TECHNICAL MEMORANDUM
American Museum of Natural History
Richard Gilder Center for Science, Education, and Innovation
CEQR No. 16DPR004M
April 25, 2018

The American Museum of Natural History (AMNH or the Museum) is proposing minor modifications to the previously approved Richard Gilder Center for Science, Education, and Innovation project. As described in greater detail below (see Section B, “Background”), the Gilder Center project was analyzed in a Final Environmental Impact Statement (FEIS) consistent with the requirements of the New York State Environmental Quality Review Act (SEQRA) and New York City Environmental Quality Review (CEQR). The New York City Department of Parks and Recreation (NYC Parks) was the lead agency for the environmental review. The Notice of Completion of the FEIS was issued by NYC Parks on November 15, 2017, following which NYC Parks released a Statement of Findings and approval of the Gilder Center project on December 4, 2017.

Elevation View of the Proposed Modifications

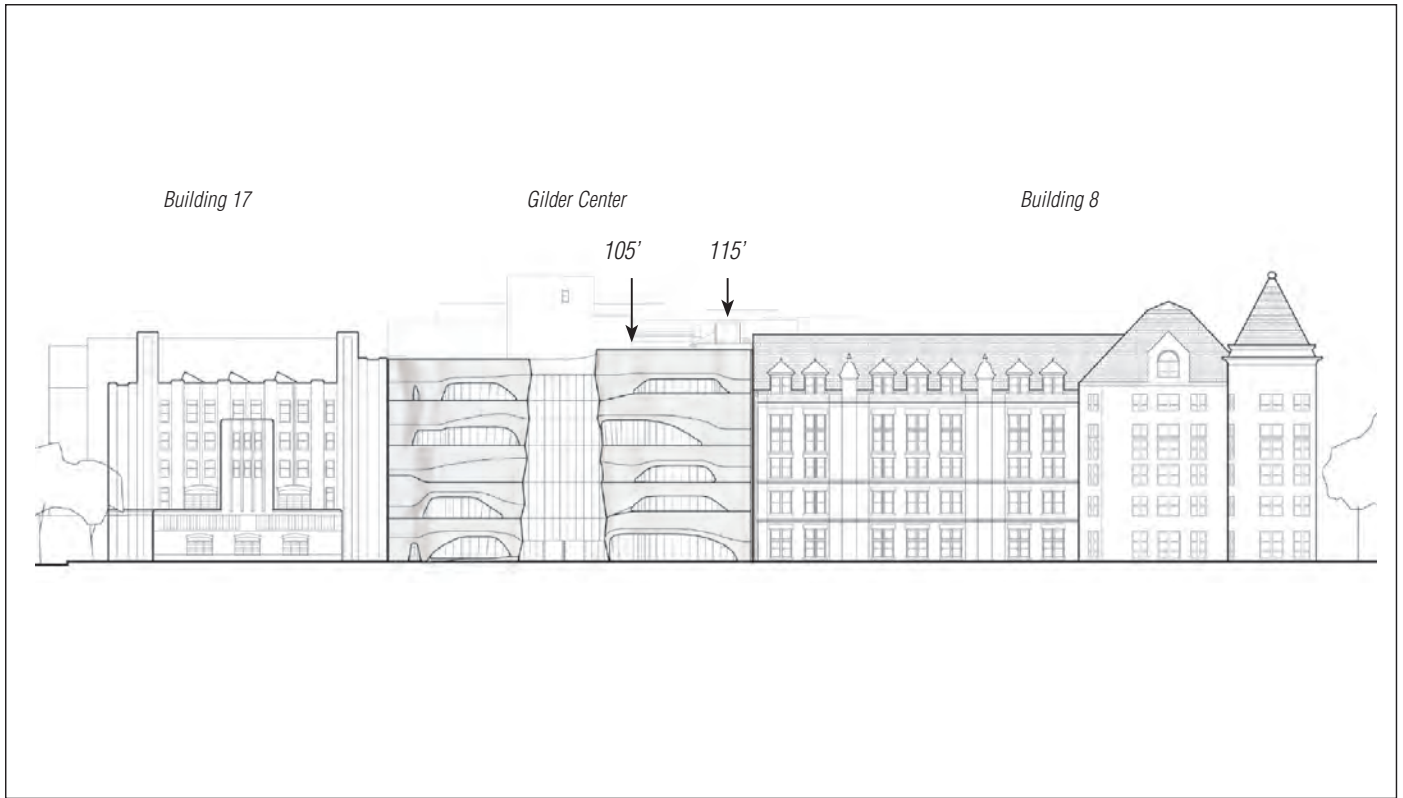
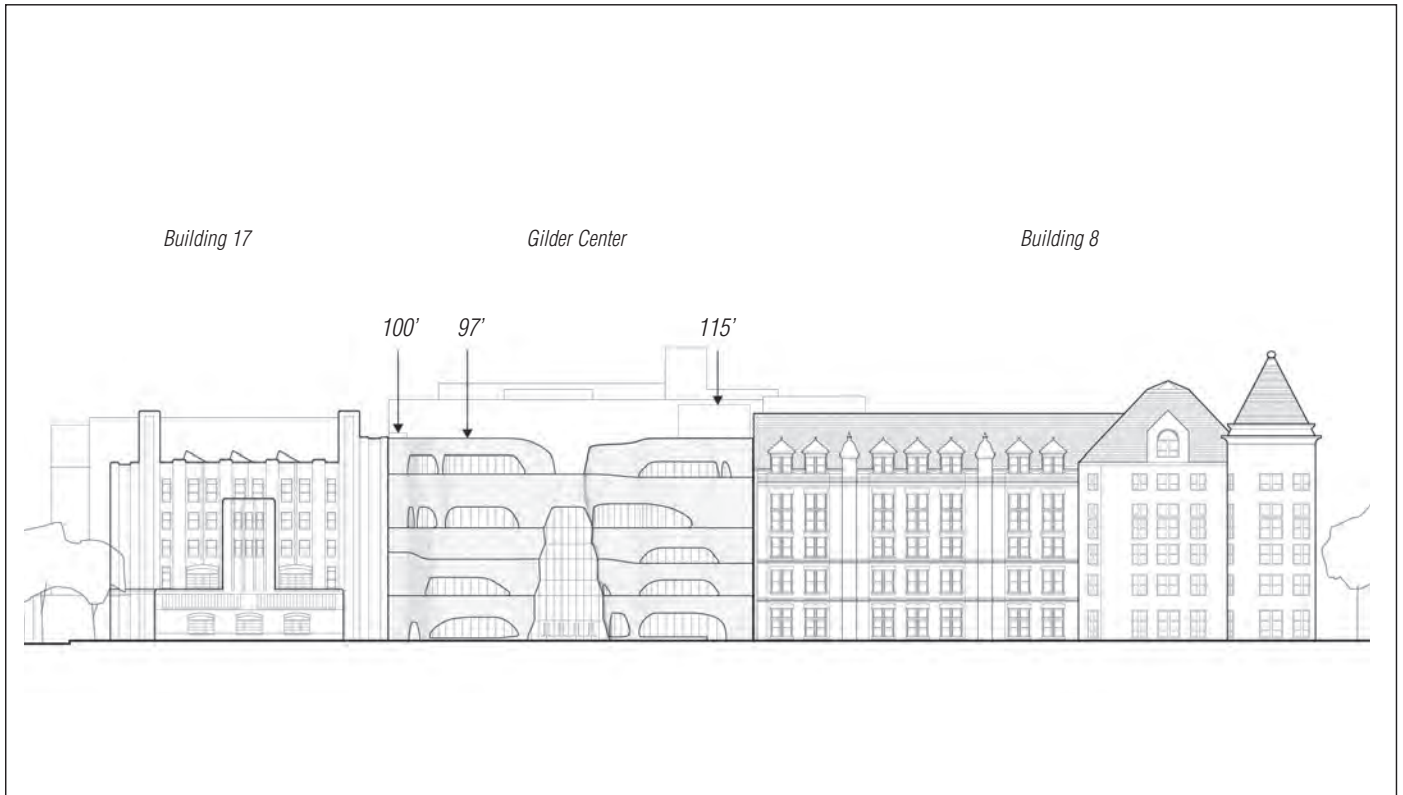
The structural support system of the north and south portions of the Gilder Center building would use both sides of the Central Exhibition Hall walls for support. This would result in an extension of the stone parapet above the central entry glass portion of the façade and a more visible angle to the stone façade of the south side, in elevation, above the central entryway (see **Figure 2**). The roof skylight would be separated into multiple smaller skylights, allowing for the roof on each side to be connected between the skylights. The parapet height of the building would be reduced from 105’ to 97’, creating a better relationship with the roof line of Building 8 adjacent to the south (see **Figure 3**). As a result of slight shifts in the undulations of the façade and the location of entries and exit doors, there would be a slight reduction in the line of the building footprint at-grade.

Certain existing structural elements would be retained, including elements of the corridors surrounding the LeFrak Theater and an adjacent exhaust duct for the parking garage (see **Figure 4**), resulting in retention of a stronger red brick vocabulary at the exterior that would be matched by changing the copper façade element to brick on the northeast portion of the Gilder Center (see **Figure 5**). Subtle curving of the corners of the plaster façade elements would maintain the aesthetic connection to the west façade. The reconfiguration of the building’s multi-story Central Exhibition Hall would result in reduced bulk at the center of the eastern façade and shifts in bulk at the north and east side of the building. A non-public connection at Level 5 to the east

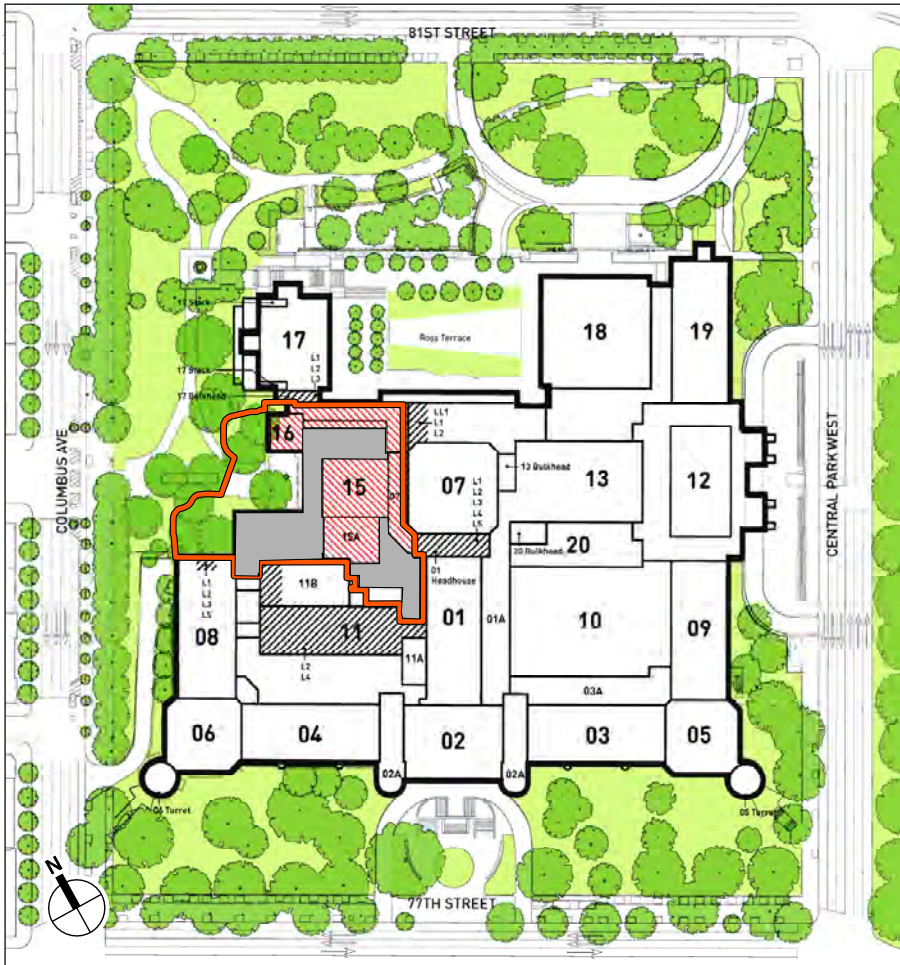
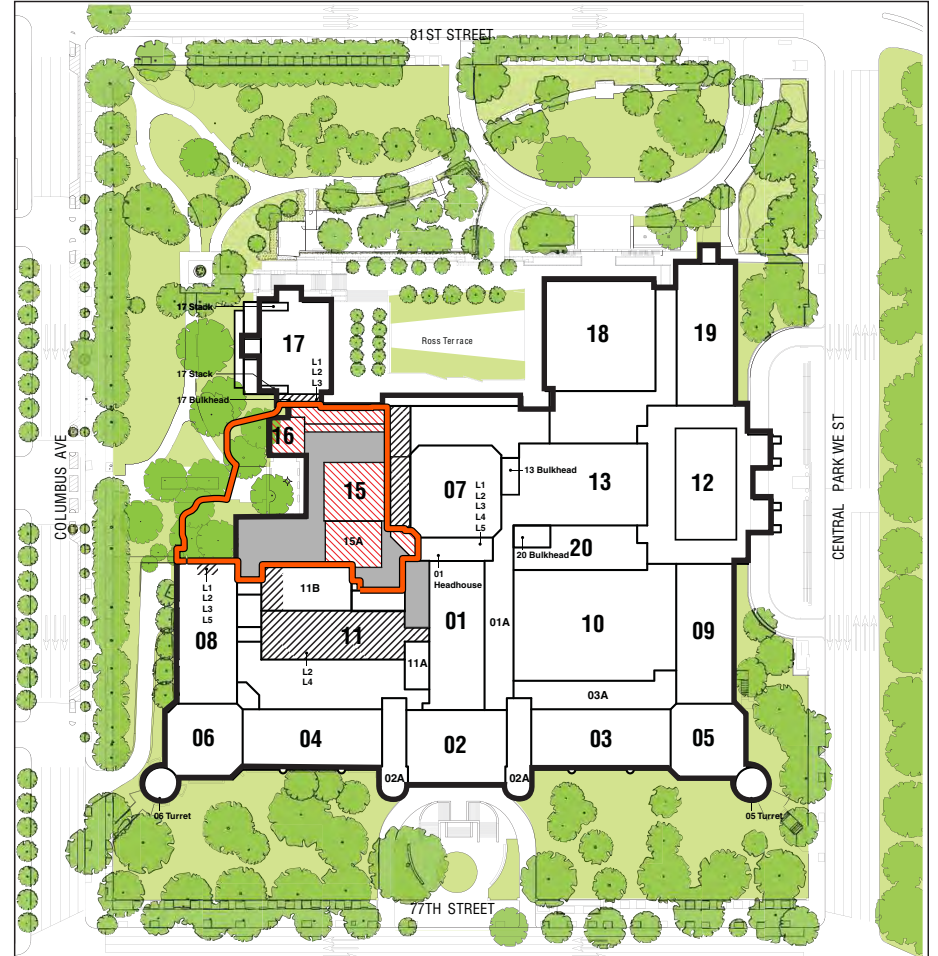
has been removed, with a corresponding reduction in the volume of the east–west connecting structure from the south side of the new building.
